RE: Response to Request for Additional Information

EPA I.D. No. FLR 000 168 203 Walton County - Used Oil Processor

Florida Transformer, Inc.

Mittauer & Associates, Inc. Project No. 1202-01-1

Attachment B.3

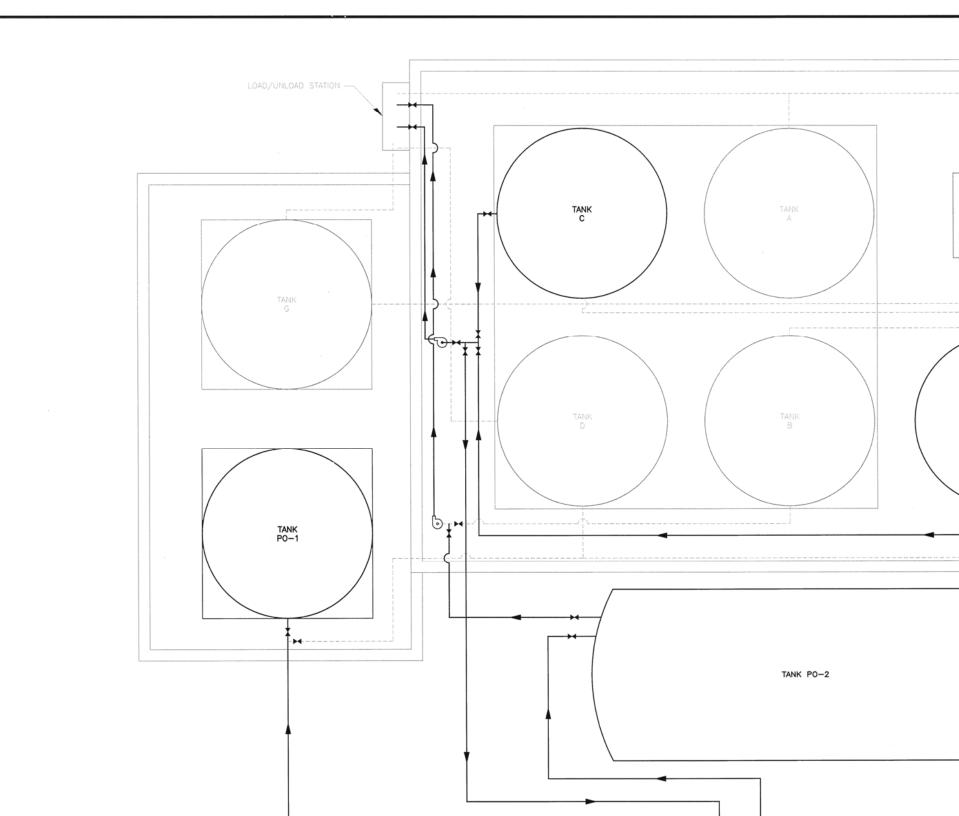
Comment No. 1 Attachment B.3, Maps and Figures, Facility Layout: Please provide a figure that identifies the location of the on-site laboratory, and the drum storage area.

Response No. 1 The revised Figure B-3d within Attachment B.3 identifies the onsite laboratory. Additionally, there are designated drum storage areas located throughout the facility in each repair shop.

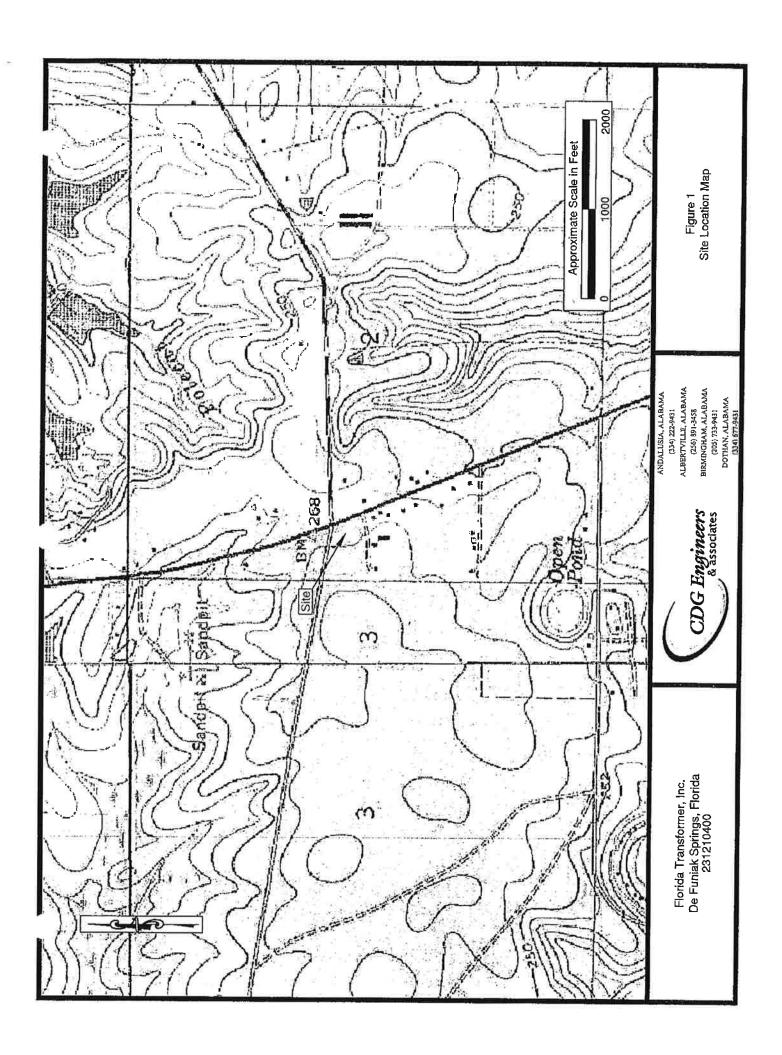
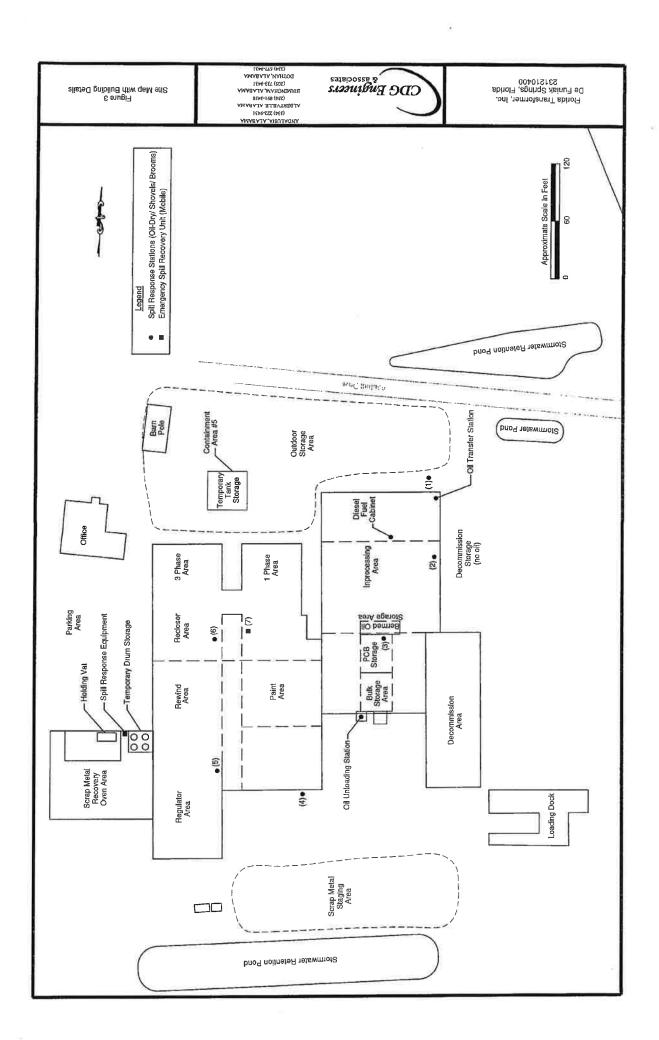
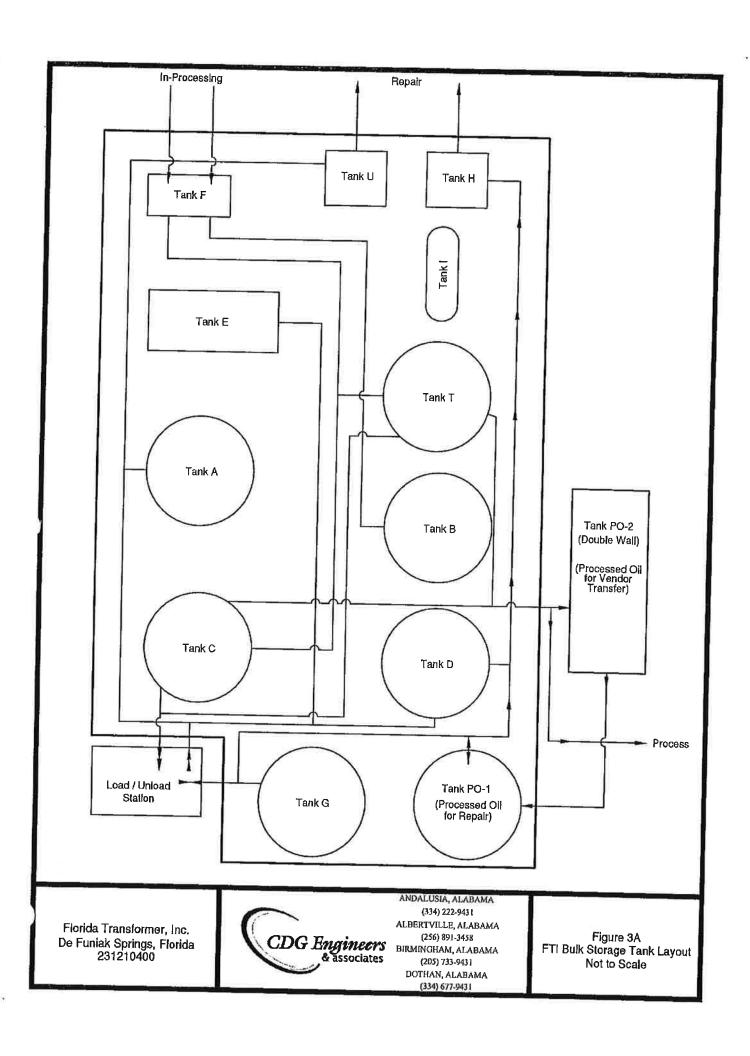
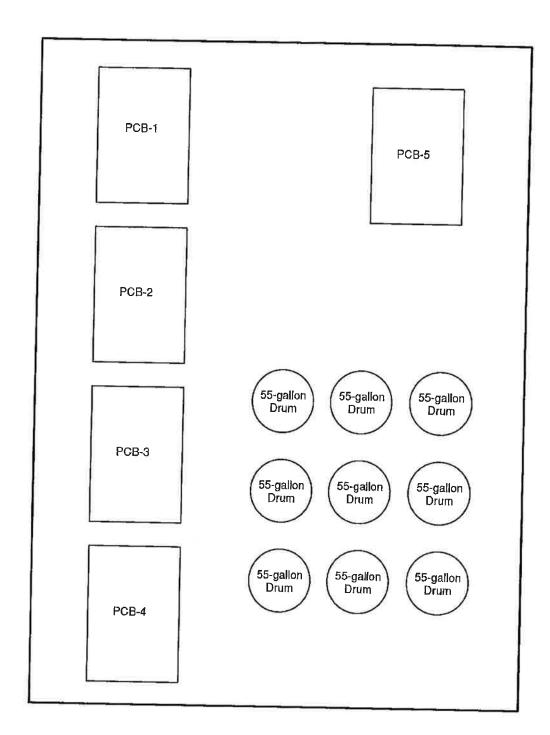
Attachment C.6, Appendix A, Figure 3A, Bulk storage area layout: Please add Tank capacities and contents. Also, add PCB-1000 to the process diagram.

Comment No. 5 Figure 3A, and Sheet B-3e: These two tank piping diagrams do not agree with each other. Please review these two maps and revise the piping connections as appropriate.

Please refer to Figure B-3e within Attachment B.3 for tank capacities, contents, and the PCB-1000 used oil processing equipment. Figure 3A is included as an Appendix to comply with the General Requirements of FTI's overall SPCC plan.

These are two separate figures and should be treated as such. Figure B-3e is an accurate, to scale, drawing of the Tank Farm area where the used oil processing will occur, and Figure 3A is strictly FTI's Bulk Storage Tank Layout.
